802.1ah/D3.8 comments MAC Translation

Maarten Vissers
October 2007

MAC Translation

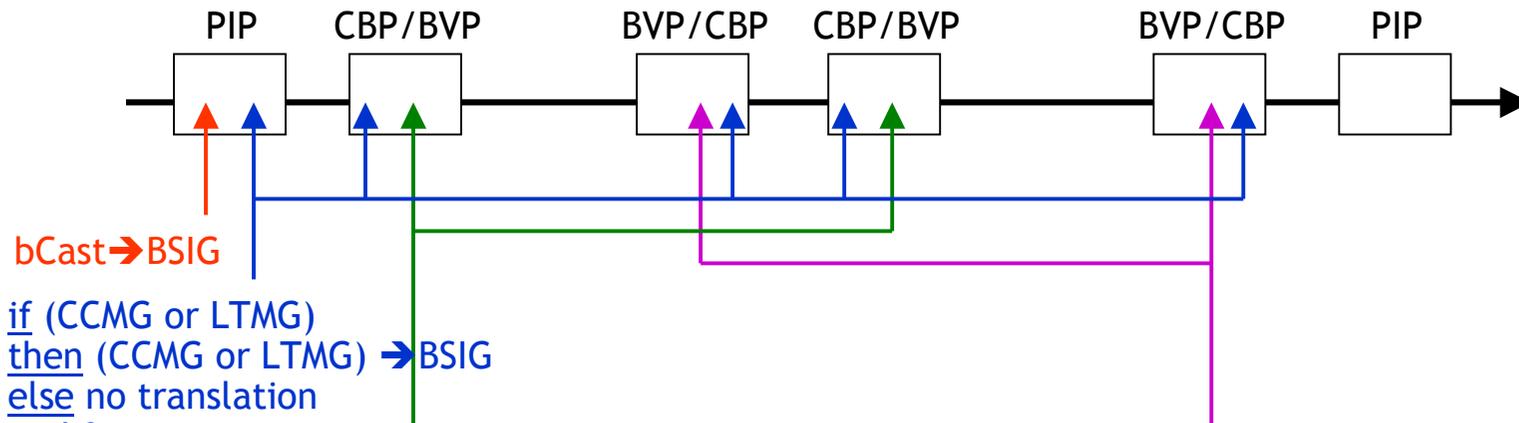
MAC translation required to restrict flooding of Backbone Service Instance frames within multipoint B-VLAN

- ❑ Not required when Backbone Service Instance frames transported within point-to-point B-VLANs or other point-to-point tunnels
 - Flooding scope of point-to-point B-VLANs/tunnels is smaller than or equal to the flooding scope of the backbone service instances carried

802.1ah/D3.8 MAC Translation specifications

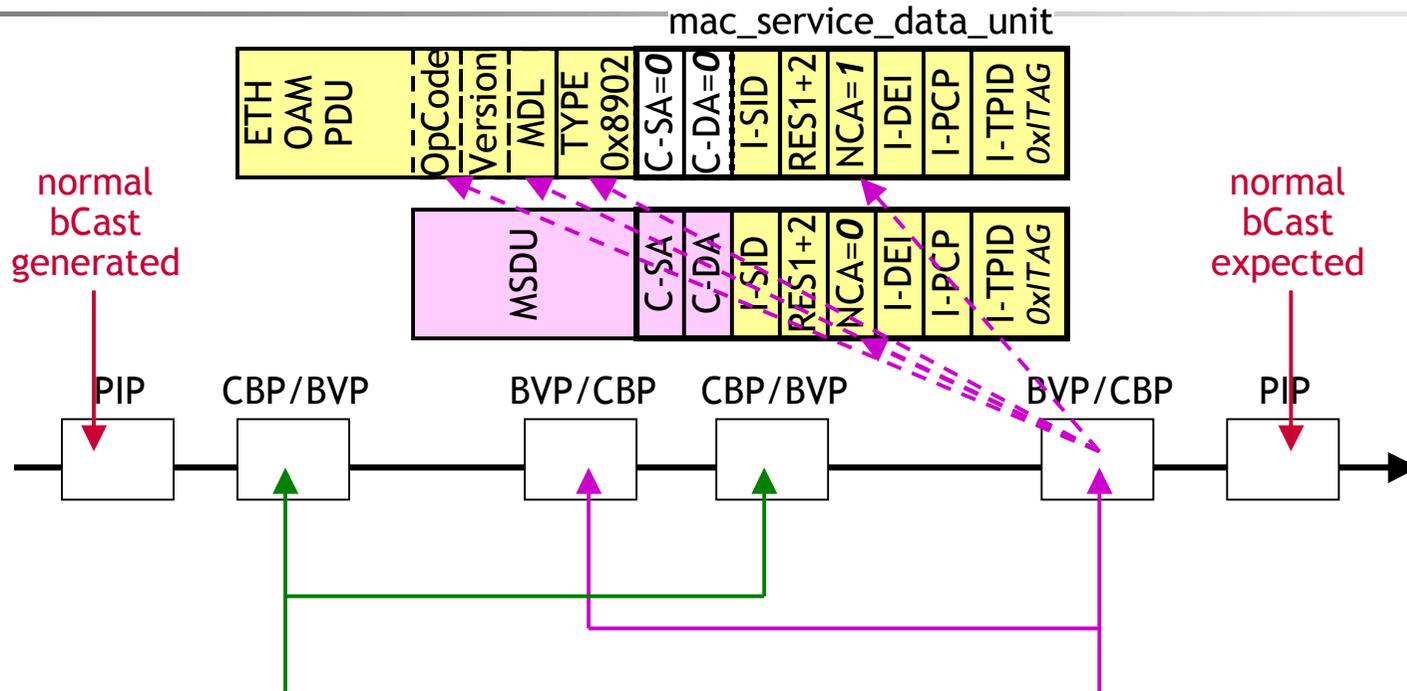
if (CCMG or LTMG)
then (CCMG or LTMG) → BSIG
else no translation
endif

if DBD
then if B-DA==BSIG
then B-DA=DBD
endif
else if Local-ISID
then B-DA=BSIG-b
else no translation
endif
endif

DBD configured as:
 - Group
 - Individual egress BVP

if B-DA==(Group or BVP)
then if Local-ISID
then B-DA=BSIG-l
else B-DA=BSIG-b
endif
else no translation
endif

Proposed MAC Translation specification

if (operPointToPoint==FALSE and (B-DA==bCast or CCMG or LTMG))
then B-DA = DBD
else no translation
endif

- DBD configured as:
- BSIG (default)
 - Group
 - Individual egress BVP

if (operPointToPoint==FALSE and (B-DA==Group/BSIG or BVP))
then if (MSDU.NCA==1 and MSDU.TYPE==0x8902)
then if MSDU.OpCode==LTM
then B-DA = LTMG(MDL)
else B-DA = CCMG(MDL)
endif
else B-DA = bCast
endif
else no translation
endif
